VSRA AGM

Notes of the Annual General Meeting held at the Rochester Hotel on 13 March 2024

Re Louise House apart-hotel, 33 Medway St.

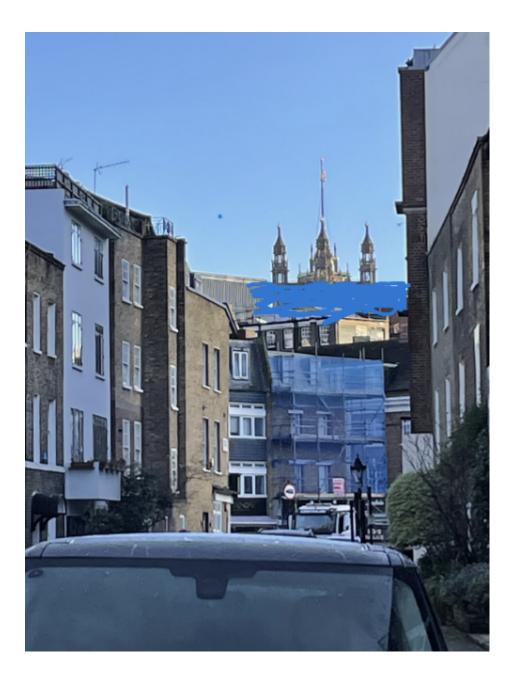
It is rare that a single proposal impinges directly on 2 conservation areas (Medway St. and Vincent Sq.) and a World Heritage Site as this one does. It does so through its massing, its height and its intrusive design. It flies contrary to the principles of a World Heritage Site, and to several of Westminster Council's own published design principles. It would be possible to have a sympathetic redevelopment on this site- this one is anything but. Some of the heritage statement, I regret to say, reads as advocacy to try to downplay the impact of this intrusive modern re-development on this sensitive site.

- 1). UNECO World Heritage Site. There are only 28 in the UK. The Palace of Westminster was inscribed as a cultural World Heritage Site in 1987 in recognition of its international importance and 'Outstanding Universal Value' (OUV). Westminster Council states that 'any development or proposal which impacts on a World Heritage Site must be assessed in terms of its OUV'. Unless I have missed it I see no such assessment in this proposal, despite the fact that it will substantially change, and degrade, some of the iconic perspectives of the Victoria Tower from this south-westerly direction, especially over the Vincent Sq. playing fields and down Maunsell Street- much enjoyed by residents and visitors from around the world. It does this by blocking out some of the current skyline, by raising the skyline (almost obliterating the current iconic view of Victoria Tower from some settings), by its mass, and by its very intrusive and unsympathetic and jarring design and colouring. UNESCO have already expressed significant concern about some recent planning decisions and highlighted that "important views of the property are vulnerable to development projects..... the integrity of the [Palace of Westminster] site is under threat". Have they been consulted?

- 2). Vincent Square Conservation Area. I would invite you to look at the photo on front page of the Council's own conservation area audit, which shows why this is going to have such an impact on this area. The development would stick out in the middle of this iconic cityscape. It is an example, to use the Council's words 'where the roofline is exposed to long views from public places'. The mass, significantly raising the skyline (both the main development and the very intrusive lift house obscure or impinge on Victoria Tower), the out-of-keeping colour, and the in-your-face design will all change this irrevocably. The current Westminster Plan says "It's absolutely vital that development must never be at the expense of our heritage. Our new approach to managing development will make sure planning for Westminster is about conservation not just preservation, and building tomorrow's heritage today". The design, if viewed from this direction (eq Maunsell Street or across the playing fields) infringes Design Principles 38B, (the character and appearance of the existing area, adjacent buildings and heritage assets), 38F (contemporary architecture and use of modern materials only where they respect and enhance their surroundings and integrate and better reveal Westminster's heritage and existing townscape), 39B (many aspects, including that development protects the skyline, prominence and iconic silhouettes of the Palace of Westminster), and 40D, 40E and 40F (Roof extensions will only be supported in principle where they do no impact adversely on heritage assets).

- 3). Medway St. Conservation Area, which Louise House sits in the middle of although just outside the boundaries. This building will dominate what the Council audit describes one of its advantages "the small scale and domestic character of the majority of the buildings." It has three Grade II listed buildings and several designated as Unlisted Buildings of Merit. It is currently a very sympathetic grouping. All the aspects of the Design Principles mentioned above apply here. Roof profiles are important to this conservation area as laid out in the audit paras 4.23-4.31. The conservation area will be substantially changed if this proposal in its current form goes ahead given the extent that Louise House will dominate it.

- 4). Whilst the historical background of the heritage statement is broadly accurate, I was startled to see it described the impact of the proposed development on Vincent Square conservation area including Maunsell St as 'neutral'. It would only be neutral if the proposed large extension was architecturally as good as the Victoria Tower World Heritage Site which it will obscure, and if it was sympathetic in style to the local architecture including many important townscapes. It is neither (and obviously neither).

- 5). It would be perfectly possible to infill between the current blocks of Louise House in a sympathetic style keeping the current roofline of the two blocks (excluding the redundant water tank) without any of these disadvantages. It could even be done in a way which enhanced the townscape if the current, redundant and highly visible, water tank was removed. But the current mass, substantial impact on the skyline both of the whole design, the prominent lift house that will extend even higher, and very unsympathetic style mean the current proposal is contrary to multiple Westminster Council design principles affecting two conservation areas and well known perspectives on a UNESCO World Heritage Site.

- 6). It is also contrary to widespread local opinion. I only received my letter on the 30th Oct, giving only 2 weeks to respond to a major proposal with many documents which will have a substantial impact on the area. If others also received it then I cannot see how this meets statutory notice, let alone a reasonable time to undertake a proper response (I would like reassurance all others did receive their letter with 21 days to respond). Many are only now becoming aware of the scale of the impact this will have on the conservation areas."
